UNITED STATES PATENT AND TRADEMARK OFFICE

APPLICATION NO.	FILING DATE	FIRST NAMED INVENTOR	ATTORNEY DOCKET NO.	CONFIRMATION NO.
10/536,545	11/07/2005	Larry Salvadori	20518/51 (S-8500)	9818

Office Action Summary	Application No. 10/536,545	Applicant(s) SALVADORI ET AL.	
	Examiner VICTORIA P. CAMPBELL	Art Unit 3763

DETAILED ACTION

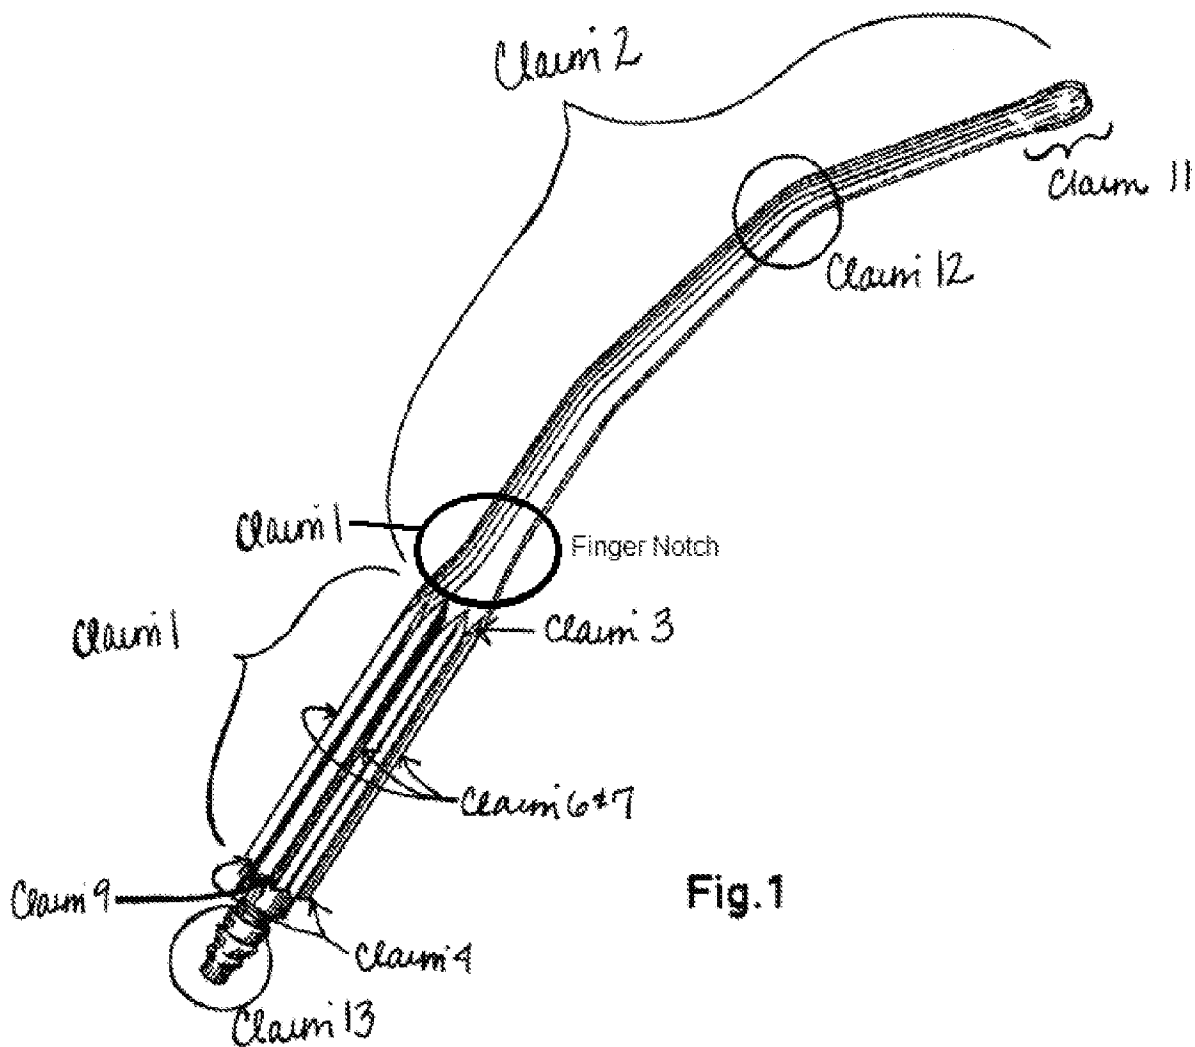
2. Claims 1-4, 6, 7, 9, 11-14, and 21 are rejected under 35 U.S.C. 102(b) as being anticipated by USPN D264,246 to Ekbladh et al. Regarding the above claims, Ekbladh et al teach the following (drawing attached for clarity):

1. A surgical instrument comprising: a handle defining a longitudinal axis, the handle having an outer surface including a plurality of longitudinal fins that define a plurality of longitudinal grooves therebetween, and said handle having at least one finger notch.
2. The surgical instrument of claim 1, further comprising an elongated tubular portion having an opening configured for suction.
3. A surgical instrument as recited in claim 1, wherein at least one of the fins project radially from the outer surface.
4. A surgical instrument as recited in claim 1, wherein a pair of the fins project radially from the outer surface and are diametrically opposed.
6. A surgical instrument as recited in claim 1, wherein two separate pairs of the fins project radially from the outer surface and are diametrically disposed.

- 7.** A surgical instrument as recited in claim 6, wherein the two separate pairs are offset 90° relative to the longitudinal axis.
- 9.** A surgical instrument as recited in claim 1, wherein the grooves include guide channels that direct fluid to a proximal end of the handle.

- 11.** A surgical instrument as recited in claim 2, wherein the tubular portion includes a passageway that extends to the opening having a nozzle.
- 12.** A surgical instrument as recited in claim 2, wherein the tubular portion has a curvature adjacent a distal portion thereof.

- 13.** A surgical instrument as recited in claim 2, wherein a proximal end of the handle has an attachment configured to communicate with a suction source.

- 14.** A surgical instrument as recited in claim 1, wherein the surgical instrument has a center of mass located distal to the handle.
- 21.** A surgical instrument as recited in claim 1, wherein the at least one finger notch is a depression that receives a thumb and forefinger of a practitioner (depression of the surface can be seen in the attached figure).

Regarding claim 14, the surgical tool depicted has a handle shorter than its elongated extension. Both portions have similar diameters, therefore the mass of the elongated extension will pull the center of mass distal of the handle.
